AMENDMENT OF SOLICITATION/MODIFICATION OF CONTRACT			1. Contract Number	Page of Pages 1 1	
2. Amendment/Modification Number DCAM-2011-B-0083-002		3. Effective Date 14-Feb-11	4. Requisition/Purchase Request No.	5. Solicitation Caption Renovation of Madison Shelter

RENOVATION OF MADISON SHELTER – Solicitation DCAM-2011-B-0083**ADDENDUM II – February 10, 2011****PROLOG Software Interface Requirement**

**RENOVATION OF MADISON SHELTER
ADDENDUM II – February 10, 2011**

ASK-8 VAULT FINISH DETAIL

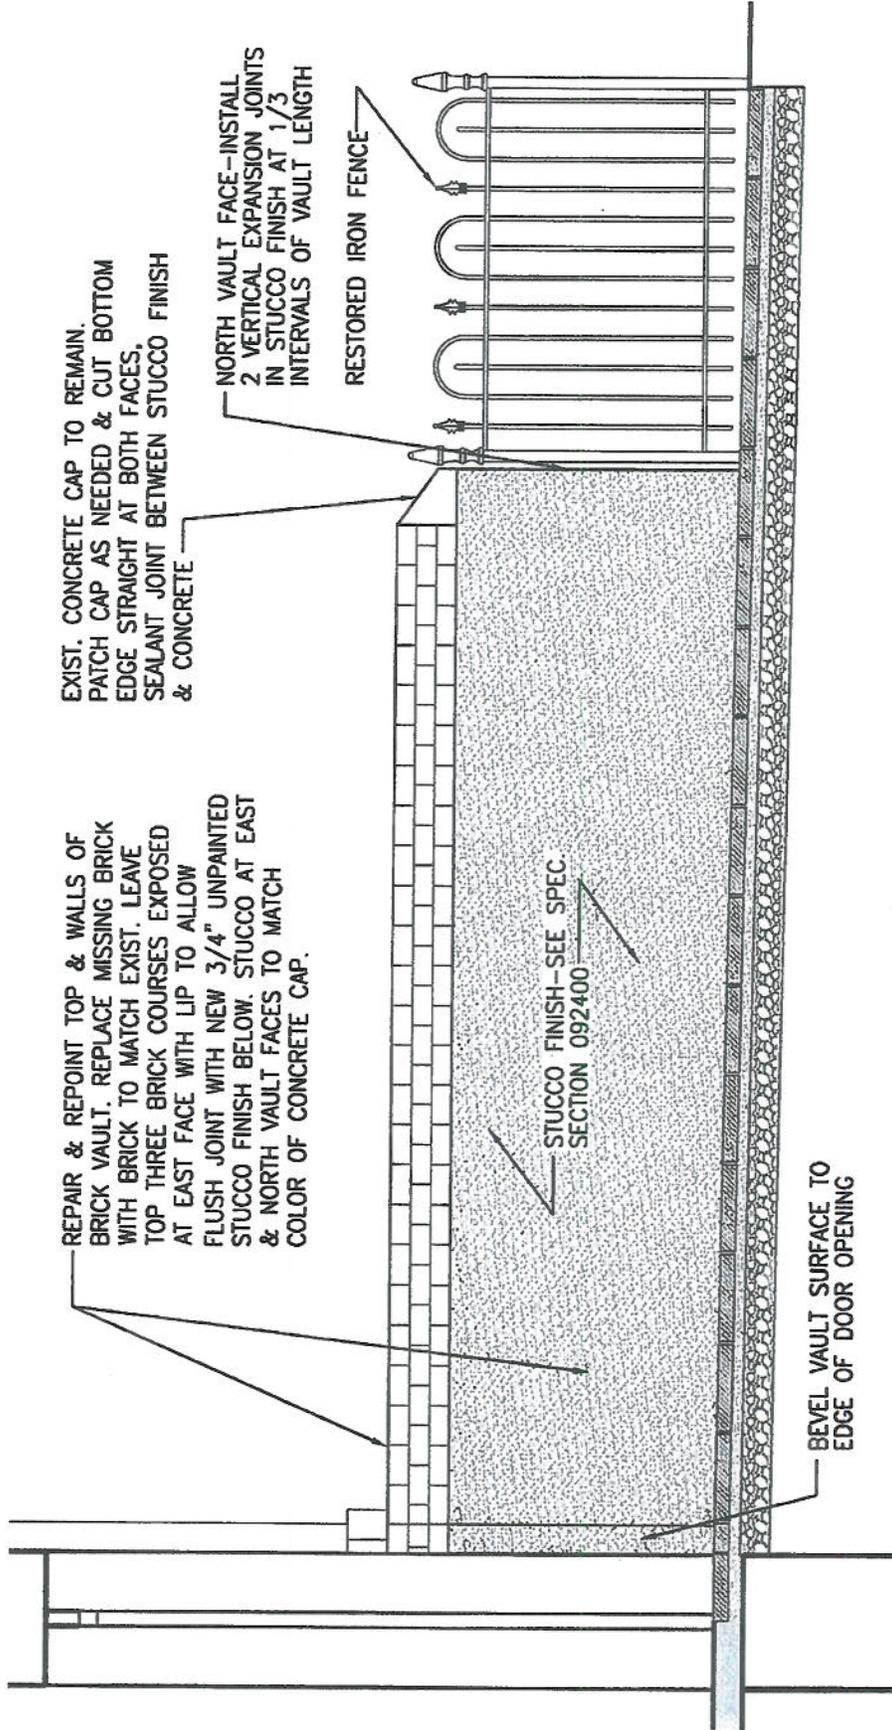
EXIST. CONCRETE CAP TO REMAIN.
 PATCH CAP AS NEEDED & CUT BOTTOM
 EDGE STRAIGHT AT BOTH FACES.
 SEALANT JOINT BETWEEN STUCCO FINISH
 & CONCRETE

REPAIR & REPOINT TOP & WALLS OF
 BRICK VAULT. REPLACE MISSING BRICK
 WITH BRICK TO MATCH EXIST. LEAVE
 TOP THREE BRICK COURSES EXPOSED
 AT EAST FACE WITH LIP TO ALLOW
 FLUSH JOINT WITH NEW 3/4" UNPAINTED
 STUCCO FINISH BELOW. STUCCO AT EAST
 & NORTH VAULT FACES TO MATCH
 COLOR OF CONCRETE CAP.

NORTH VAULT FACE--INSTALL
 2 VERTICAL EXPANSION JOINTS
 IN STUCCO FINISH AT 1/3
 INTERVALS OF VAULT LENGTH

STUCCO FINISH--SEE SPEC
 SECTION 092400

BEVEL VAULT SURFACE TO
 EDGE OF DOOR OPENING
